2018ECI018 – RANDWICK – DA887/2018: 150-162 BARKER STREET, 1 JANE STREET & 8-20 YOUNG STREET, RANDWICK

We write on behalf of *Cbus Property Sydney Residential Pty Ltd* (the Applicant) regarding **DA887/2018** which seeks consent for a mixed-use development at Lots N1 and N2, Newmarket Randwick. The application is to be determined by the Sydney Eastern City Planning Panel at the public meeting scheduled for Tuesday 30 July 2019.

2018ECI018 – Randwick – DA887/2018 – Proposed DA Conditions of Consent

2018ECI018 – Randwick – DA887/2018 – Proposed DA Condition of Consent 4A

Figure 1 – Lot N2 upper level study options

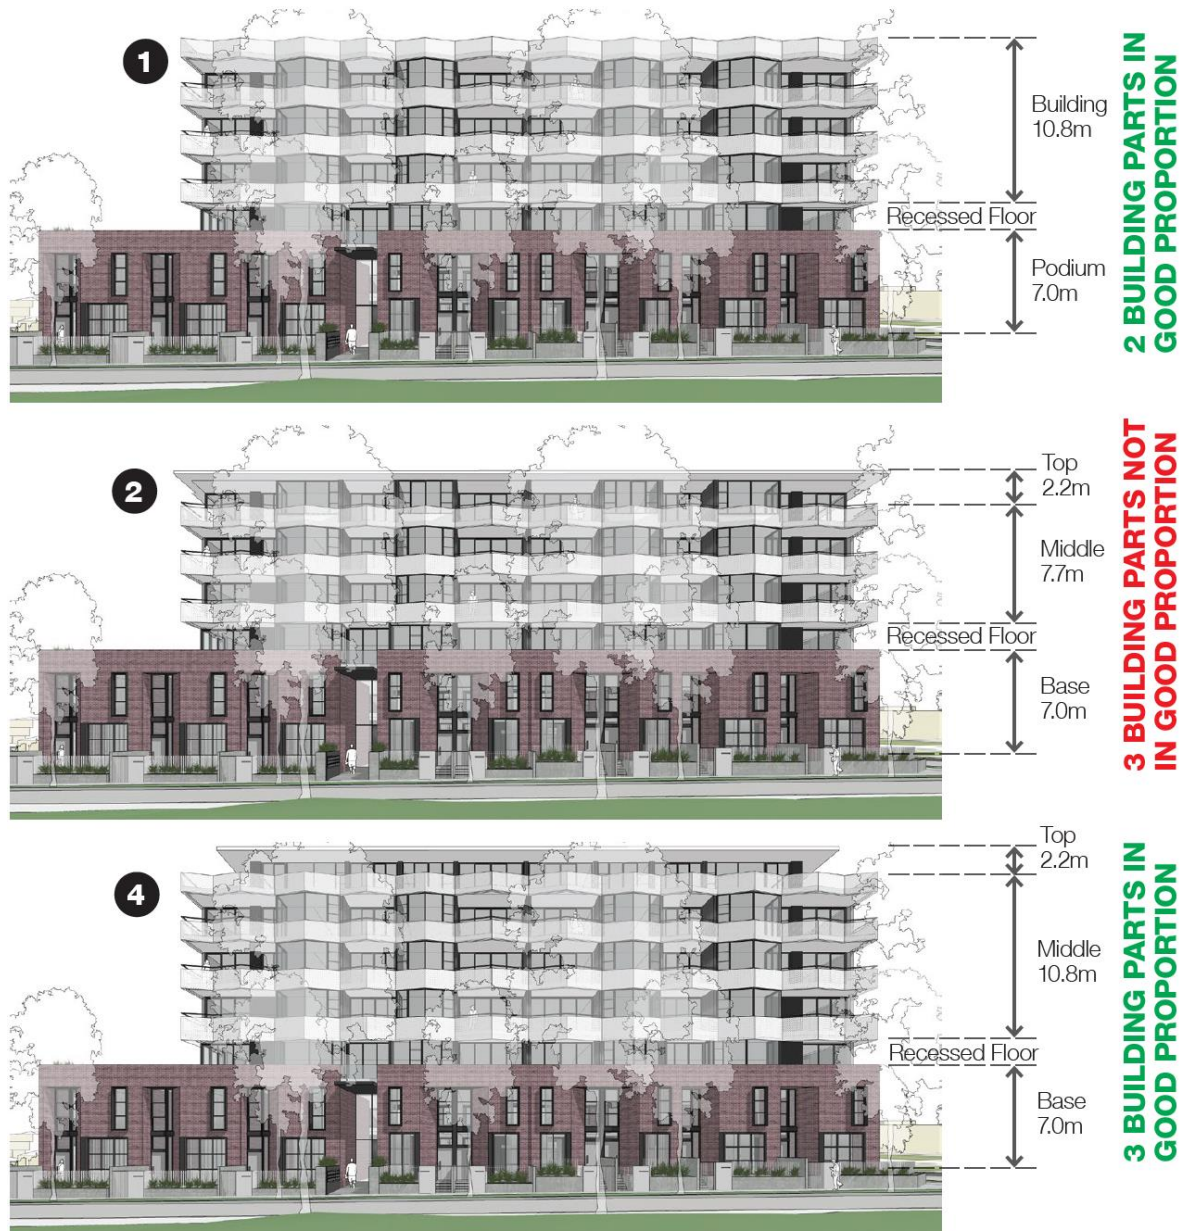
a. The roof of the six storey building on Lot N2 shall be amended to be consistent with Option 2 as shown on the roof option study in the proportion analysis section dated 12 March 2019 and prepared by BATESSMART. Details shall be submitted to and approved by the Manager Development Assessment prior to a Construction Certificate being issued for the development.

The Panel feels that further study is required to distinguish this level as a roof top level from the three middle levels below creating a base related to the townhouses, a middle layer and an upper layer against the sky. This could be achieved with a simpler roof form for the roof that does not mimic, as an extrusion, the level below and also allows for views through to the sky from balconies. The proposed treatment of the upper parapet is not a convincing way to distinguish this level from those below.

The proposed building façade can be further refined. Components on the building façade are to be developed to differentiate the bottom, middle and top. This can be achieved by providing upper roof setback to distinguish the upper floor and allow for views through to the sky from these balconies.

Further options were then tested by Bates Smart and provided to the Panel in March 2019. This analysis firmly stated that the project Architect, Applicant and team respectfully disagreed with the Panel's opinion that the building façade needed a defined bottom, middle, and top. It is our opinion that the scale and proportions of Lot N2 do not lend themselves to three façade components. Rather, the proposed scheme provides two building components comprising a podium and body in good proportion. This is demonstrated in Figure 1.

In order to create three building parts in good proportion the building would require an additional level. However, this would result in a significant non-compliance with the maximum height of building standard and approved Stage 1 building envelope.

We request that condition 2(a) be deleted on the basis that it provides a poorer response in terms of context and neighbourhood character, built form and scale, and aesthetics.

The proposal has been carefully designed to respond to the **context and neighbourhood character** of the Struggletown Conservation Area. The two-storey base relates directly to the **Built Form and Scale** of the conservation area. Above the base, a simple four storey volume relates to the taller buildings fronting Young Street and the new park. The proposed faceted roof profile provides a skyline silhouette which recalls the hipped roof profiles of the conservation area. This would be lost with a flat roof as proposed by the panel. We strongly believe that the faceted plan profile without expressed roof plane provide better proportions and a more contextual response to **Aesthetics**.

We therefore, respectfully request that the Sydney Eastern City Planning Panel remove Condition 2(a) from the conditions of consent prior to determination.
